Re: Pisgah Bottom Road Diagnostic Review Recommendations

A Diagnostic Review at the Pisgah Bottom Road grade crossing (US DOT# 299 743D) was conducted on September 27, 2016. As a result of the review, the following changes are needed to bring this location into compliance with the 2009 Edition of the Manual on Uniform Traffic Control Devices (MUTCD):

W10-5

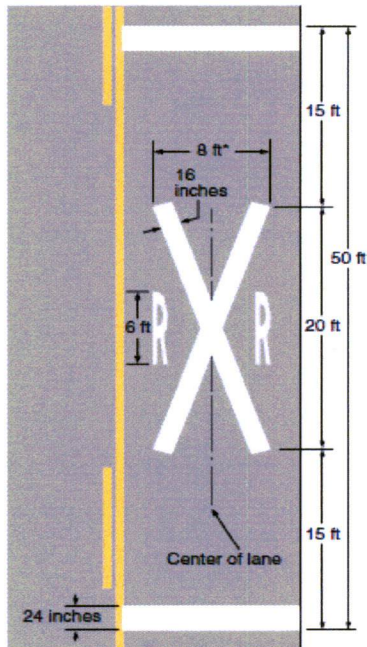
- 3) A Low Ground Clearance sign (W10-5) should be installed at the nearest intersecting highway where a vehicle can detour, or at a point on the highway wide enough to permit a U-turn. Since the Low Ground Clearance sign might not be readily recognizable by the public, the Low Ground Clearance sign should be accompanied by the Low Ground Clearance education plaque (W10-5P) and is to remain in place for at least 3 years after the initial installation of the W10-5 sign. Additionally, an Ahead plaque (W16-9P) should be installed below the W10-5 and W10-5P. For convenience, here is a picture of the W10-5, with the W10-5P and W16-9P plaques:

A - Grade crossing pavement marking symbol

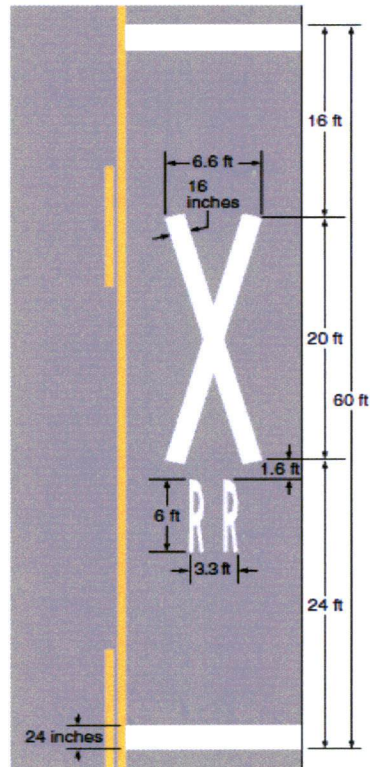
- 4) Stop lines should be added on the east and west approaches to the crossing. It should be a transverse line, perpendicular to the traveled way and should be placed no closer than 15 feet from the nearest rail.
- 5) Grade Crossing Pavement Markings should be added on the east and west approaches in retroreflectorized white. For placement, refer to Figure 8B-6 on Page 765 of the 2009 MUTCD. For convenience, here's an illustration of the needed Grade Crossing Pavement Markings:
